Access Compliance Report

Public Rights-of-Way

(Pedestrian Signals)

Intersection ID: N/A	Main Street:	Cross Street: N/A	Location: N/A
ADA ID: 79AE99117C2E	Signal Type: Two Push Buttons-Non APS	Overall Compliance: No	Severity Score: BTN 1:N/A BTN 2: N/A No BTN: N/A
Codes/Mitigation Info/Possible Solution		Field Measurements/Component Compliance

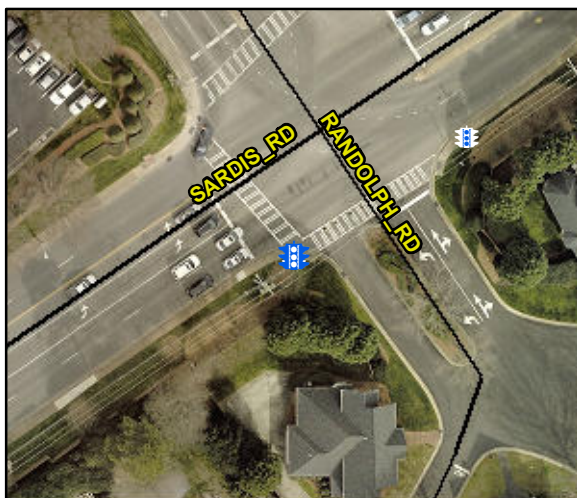
PROW/ADA: TMUTCD 4e.08, R404.2, R404.3, R406.2

Compliance	Description	Data	Compliance	Description	Data
	Button Count	Button2	N/A	Distant to Additional Button (in)	N/A
	Additional Button Present?	No		Additional Button ID	N/A
N/A	Signal Buttons Required?	N/A	N/A	Additional Ped Posts Required	N/A
	How Many Ped Street Xings?	2		Located In An Island/Median?	No
N/A	B 1 Sign Present?	Yes	N/A	B 2 Sign Present?	Yes
Yes	B 1 Sign Purpose?	Yes	Yes	B 2 Sign Purpose?	Yes
Yes	B 1 Sign Lettering & Contrast?	Yes	Yes	B 2 Sign Lettering & Contrast?	Yes
Yes	B 1 Parallel To XWalk?	Yes	Yes	B 2 Parallel To XWalk?	Yes
Yes	B 1 PAR to Button?	Yes	Yes	B 2 PAR to Button?	Yes
Yes	B 1 PAR to XWalk?	Yes	Yes	B 2 PAR to XWalk?	Yes
Yes	B 1 Clear Floor Space?	Yes	Yes	B 2 Clear Floor Space?	Yes
N/A	B 1 FWD Approach?	Yes	N/A	B 2 FWD Approach?	Yes
N/A	B 1 FWD Approach Constrained?	No	N/A	B 2 FWD Approach Constrained?	No
No	B 1 FWD Approach Reach (in)	14.0	No	B 2 FWD Approach Reach (in)	8.0

N/A	B 1 FWD Approach Width (in)	N/A	N/A	B 2 FWD Approach Width (in)	N/A
N/A	B 1 FWD Approach Obstruction?	Yes	N/A	B 2 FWD Approach Obstruction?	Yes
N/A	B 1 FWD Approach Obstruction Dist (in)	8.0	N/A	B 2 FWD Approach ObstructionDist (in)	6.0
N/A	B 1 PARA Approach?	Yes	N/A	B 2 PARA Approach?	Yes
N/A	B 1 PARA Approach Constrained?	No	N/A	B 2 PARA Approach Constrained?	No
Yes	B 1 PARA Approach Reach (in)	7.0	Yes	B 2 PARA Approach Reach (in)	8.0
N/A	B 1 PARA Approach Width (in)	N/A	N/A	B 2 PARA Approach Width (in)	N/A
N/A	B 1 PARA Approach Obstruction?	Yes	N/A	B 2 PARA Approach Obstruction?	Yes
N/A	B 1 PARA Approach Obstruction Dist (in)	6.0	N/A	B 2 PARA Approach ObstructionDist (in)	6.0
No	B 1 Clear Floor Space Slope (%)	3.0	Yes	B 2 Clear Floor Space Slope (%)	2.8
Yes	B 1 Clear Floor Space XSlope (%)	0.7	Yes	B 2 Clear Floor Space XSlope (%)	1.3
N/A	B 1 PAR Slope (%)	1.4	N/A	B 2 PAR Slope (%)	4.1
Yes	B 1 Height (in)	43.5	Yes	B 2 Height (in)	43.5

Yes	B 1 Clear Xing Direction?	ClearlyMarked	Yes	B 2 Clear Xing Direction?	ClearlyMarked
	B 1 Crossing Direction	To NE		B 2 Crossing Direction	To NW
Yes	B 1 DistanceTo XWalk (in)	0.0	Yes	B 2 DistanceTo XWalk (in)	0.0
No	B 1 DistanceTo Curb (in)	77.0	Yes	B 2 DistanceTo Curb (in)	64.0
Yes	B 1 Diameter (in)	2.0	Yes	B 2 Diameter (in)	2.0

Possible Solutions: Replace Signal Push Button With APS Button on New Post. Remove & Relocate Sign. Provide Push Button Extension.
